SERVICE BULLETIN 114

15 July 1983

SUBJECT Loose valve stem packing nut on vapor pilot light valves used on Raven fuel tanks and burner assemblies.

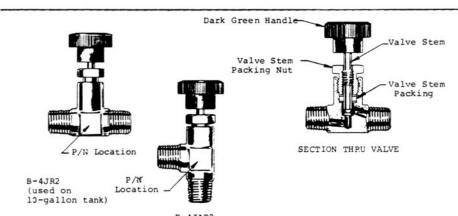
- Torque wrench calibrated in in-lbs.
- 9/16" "crow's foot" wrench. (During use, the "crow's foot"
 must be oriented 90 degrees to the torque wrench to prevent
 inaccurate torque readings. See Figure 2.)
 OR -
- Torque wrench calibrated in in-lbs and a 9/16" socket. (Removal of the valve handle will be required before tightening the valve stem packing nut. When reinstalling valve handle, use a drop of medium-strength thread sealant, such as Locktite 242, on the set screw.

- An open-end 9/16" wrench and a scale or similar device used to measure a force applied perpendicular to the wrench. (Torque is the product of force multiplied by lever arm length about an axis of rotation. To determine force which must be applied to wrench, divide required torque value by wrench length from valve stem to point of application of force. Example: For a torque value of 60 in-lb, a six-inch effective wrench length requires a force of 10 lbs applied perpendicular to the wrench at its end [60 in-lb ÷ 6 in = 10 lbs force].)
- (e) Check for proper operation as described in 1(b) and that the valve shuts off completely when closed.
